Staff Report
City of Richmond, Virginia

Commission of Architectural Review

2. COA-116136-2022	Final Review	Meeting Date: 8/23/2022
Applicant/Petitioner	Suzanne Ross, Highwoods Properties	
Project Description	Replace existing brick patio with stamped concrete pavers.	
Project Location		
Address: 106 Shockoe Slip		
Historic District: Shockoe Slip		
High-Level Details: - The applicant is proposing to replace the brick pavers on a raised patio (constructed in 1996) with stamped concrete pavers that resemble brick. The pavers will be installed using a pedestal system. - The stamp concrete pavers are only proposed on the raised patio located to the east of Shockoe Slip, as indicated on the map to the right. - This request is being made to allow access to piping below when maintenance is needed.		
Staff Recommendation	Approval, with Conditions	
Staff Contact	Alyson Oliver, alyson.oliver@rva.gov , (804) 646-3709	
Previous Reviews	None.	
Conditions for Approval	Staff recommends approval of this request with the following condition: Replacement of the existing brick pavers with stamped concrete be restricted to only the raised patio located to the east of Shockoe Slip.

Figure 2. Example of proposed concrete paver.

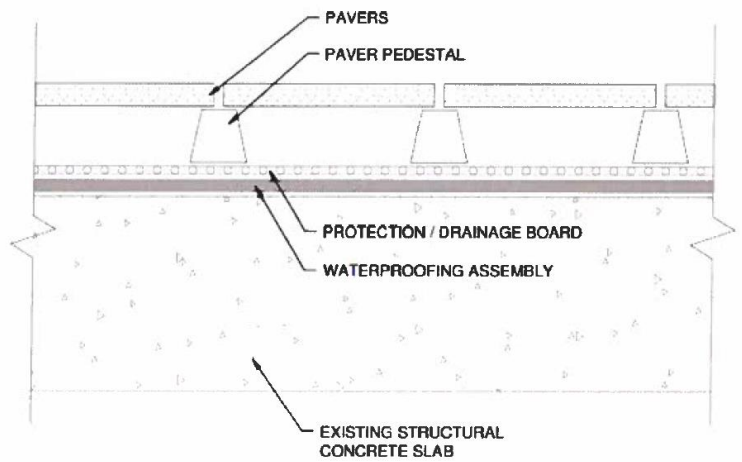
Guideline Reference	Reference Text	Analysis
Standards for Site Improvements , Sidewalks & Curbs, pg. 76	4. <i>Brick or granite pavers are the most appropriate choice in most Old and Historic Districts</i> 7. <i>Sidewalks and curbs should be built of common building materials found throughout the District. Generally, simple paving designs are more compatible with the diverse building styles and better unify the various elements found on streets throughout Old and Historic Districts. The use of more than two paving materials within an area is discouraged.</i>	The applicant is requesting to replace the existing brick pavers used on an elevated plaza that was constructed in 1996. The parking garage below the plaza has experienced several leaks over the years. Each time there is a leak, the bricks must be removed and replaced to perform the necessary maintenance. The applicant is requesting to replace the existing brick pavers with concrete pavers, colored and stamped to look like brick (see Figure 2). The applicant also proposes to install waterproofing to minimize any future leaks. The concrete pavers will be installed on a pedestal system above the waterproofing (see Figure 3). Concrete pavers are not typically an appropriate choice in a City Old and Historic District. However, staff is supportive of this request because the concrete pavers will only be used on the elevated portion of the plaza, which is minimally visible at the pedestrian level (see Figure 1). To minimize the visual impact, <u>staff recommends that concrete pavers only be used on the raised patio located to the east of Shockoe Slip</u>. Sidewalks outside of the elevated plaza and any other elevated plazas on the property are to remain brick.
